Application of Wisconsin Public Service Corporation for Authority to Construct and Place in Operation a New Multi-Pollutant Control Technology System for Unit 3 of the Weston Generating Station, Marathon County, Wisconsin

Docket No. 6690-CE-197

**Direct Testimony of Jeremy Fisher, Ph.D. On Behalf of Clean Wisconsin**

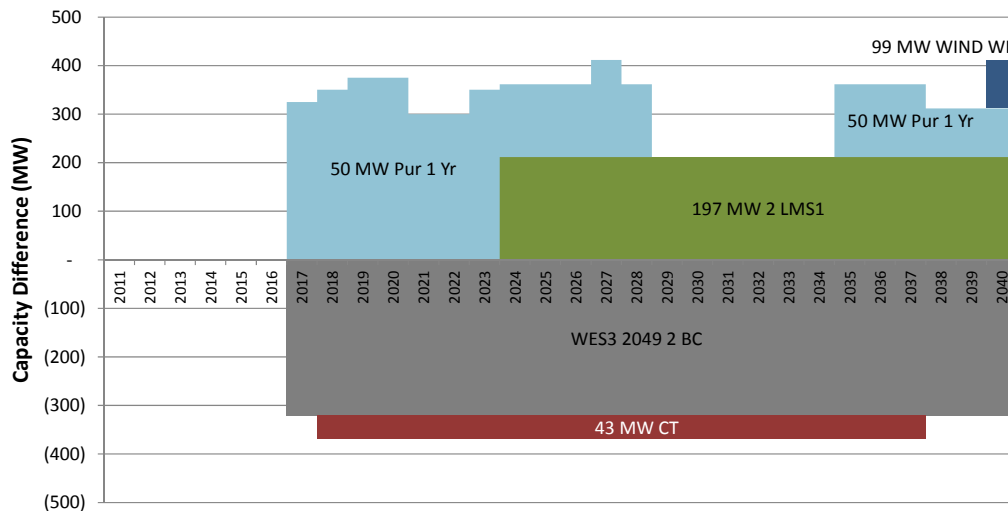
24 **Figure 3**, below, shows the difference between the EGEAS capacity solution for  
25 the Weston 3 replacement scenario (Future 7, scenario 9) and the ReACT scenario  
26 (Future 7, scenario 1). The retirement of the Weston 3 unit is shown as the  
27 negative 321 MW capacity reduction in gray starting in 2017. The [REDACTED] is in  
28 orange, starting in 2014. When this [REDACTED] disappears in 2024, the capacity is  
29 replaced by a 197 MW CC unit and 150 MW of capacity purchases from the  
30 market in 50 MW blocks ("50 MW Pur 1 Yr").
